NUCLEAR REGULATORY COMMISSION

Title: Advisory Committee on Reactor Safeguards

Date: Wednesday, December 1, 2021

19 My name is Michelle Bales. I work in the
20 Office of Research, and I will be presenting, along
21 with my colleague Lucas Kyriazidis, the Research
22 Information Letter 2113.

Element 1: Empirical threshold at which fuel pellets become susceptible to fine fragmentation

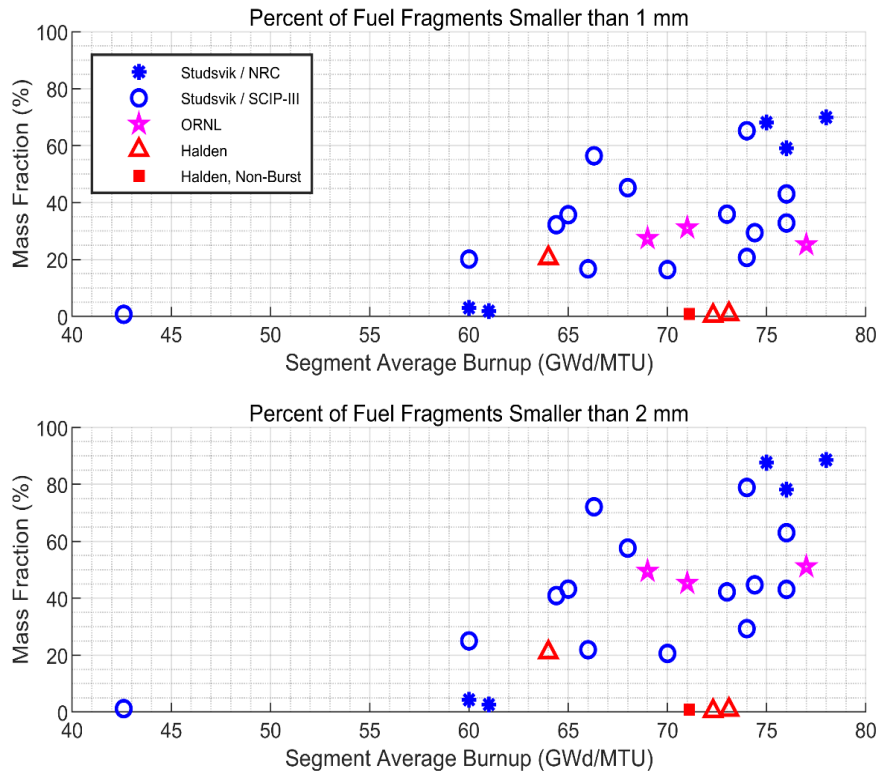
13 So, figure 3 in the report shows two data
14 points near 60 gigawatt days per MTU with fine
15 fragmentation near zero. And those PWR rods were
16 tested within the FISA program, with a rod average of
17 55.2 gigawatt days per MTU, and showed no fuel loss
18 during the LOCA test.

19 The SCIP-III results at the segment formed
20 of 50 gigawatt days per MTU in figure 3 indicates a
21 relatively small degree of fine fragmentation compared
22 with the test with second burnup exceeding 65. The
23 specific test was a BWR rod. And while some smaller
24 fine fragments were observed, the majority of the
25 fragments were greater than 2 millimeters, contrary to

1 figure 3 in the draft RIL. And in the SCIP-III
2 program, it states that 90 percent of the fragments
3 were larger than 1 millimeter.

1 MS. BALES: Right. So, I agree with you
2 that -- you know, I saw that comment this morning and
3 looked up in the NUREG, and we need to clarify that in
4 the RIL because it is accurate to say that the value
5 for that was the right average, where the rest of the
6 reported results are segment averages.
